**SUBJECT: Wireless Telecommunications Facility Permit Application
(T-Mobile Site # LA33664E)**

NOTICE OF INCOMPLETENESS

**Subject: First Screencheck Comments - Wireless Telecommunication Facility
Permit T-Mobile Site #LA33664E; W/O 10876 Culver Blvd**

**ATTACHMENT 1
FIRST SCREENCHECK COMMENTS
WIRELESS TELECOMMUNICATION FACILITY PERMIT
T-MOBILE SITE #LA33664E – W/O 10876 CULVER BLVD**

A-2

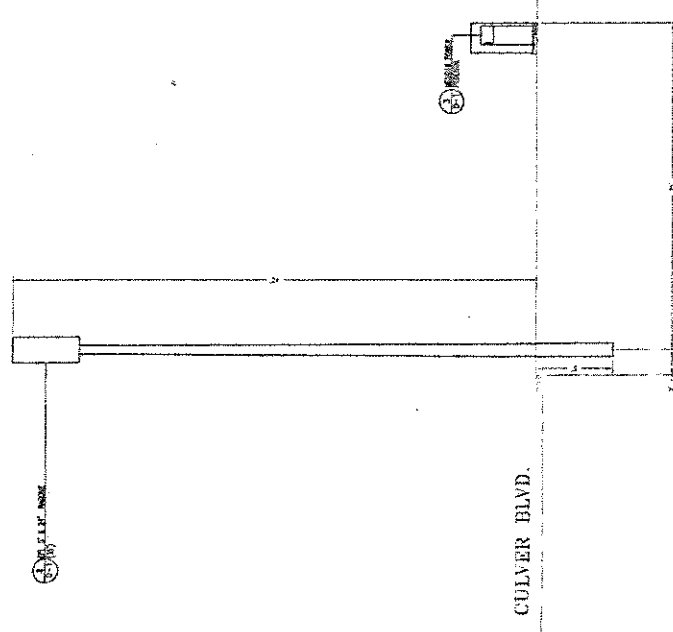
28. Label and dimension the sidewalk.
29. Label and dimension the public right of way.
30. Label surrounding buildings and land uses.
31. Show setback dimensions to the nearest residential property in all directions.

SHEET TITLE:
SITE
ELEVATION
SHEET NUMBER:
A-3

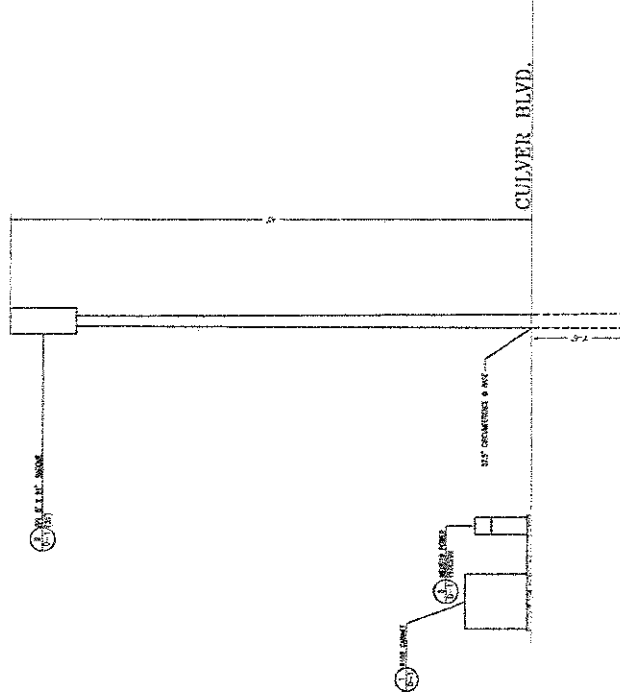
32. Add a note to the plans specifying the color of the pole. The pole shall be a neutral, non-glossy color.
33. Add a note to the plans indicating that the radome will be painted to match the color of the pole.
34. Add a note to the plans indicating that the equipment cabinet will be painted to match the color of the pole.
35. Add a note to the plans indicating that all cables shall be fully concealed.
36. Add a note to the plans that a sign shall be placed on the equipment cabinet that lists a telephone number to contact in case of emergency.
37. Provide a slimmer radome that is more in scale with the pole.

Notes: - Specify color of pole

- Indicate Pole name will be painted to Match pole color
- Indicate Address will be fully connected
- Indicate a sign will be placed on cabinet with phone number for Emergency Contact.

SECRET
D-1

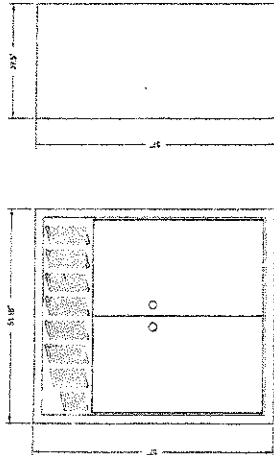
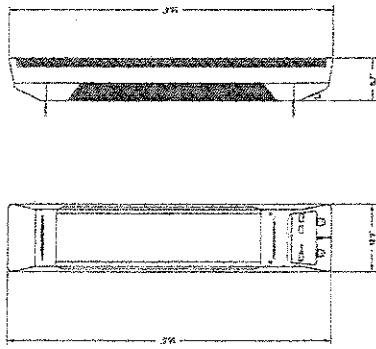
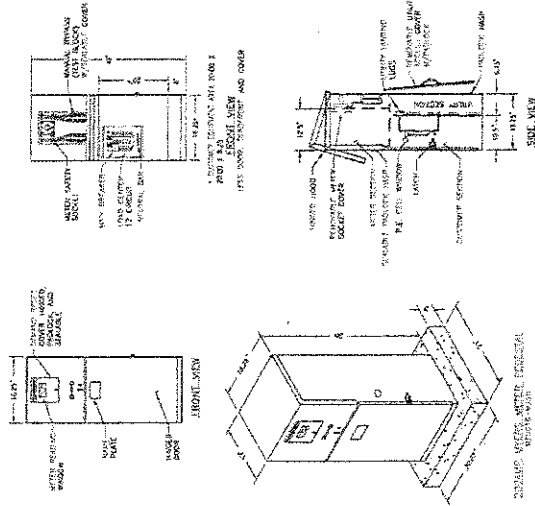
38. Provide detail for radome including height and diameter dimensions

Proide daniel for
Radome.

SHEET TITLE:
CONCRETE PAD
 SHEET NUMBER:
D-2

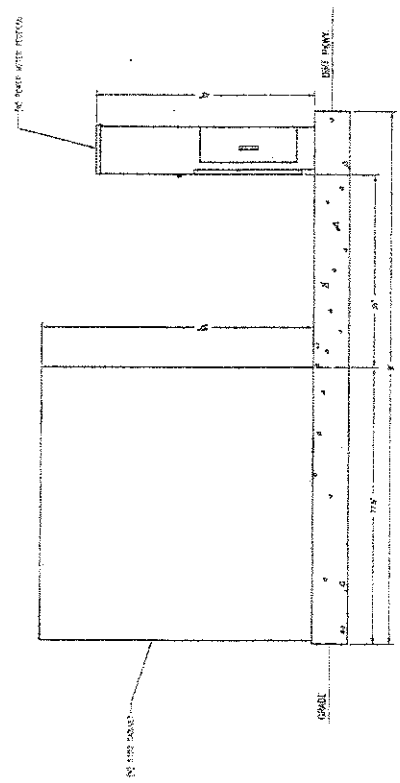
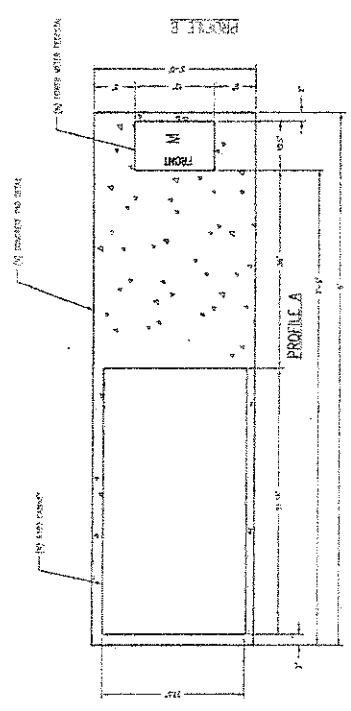
39. Decrease the size of the concrete pad to minimize the impact to the landscaped parkway.
40. Provide landscape screening around ground equipment. Depict landscaping on Sheet D-2.

*Decrease size
 of concrete.
 Locate equipment
 closer together.*
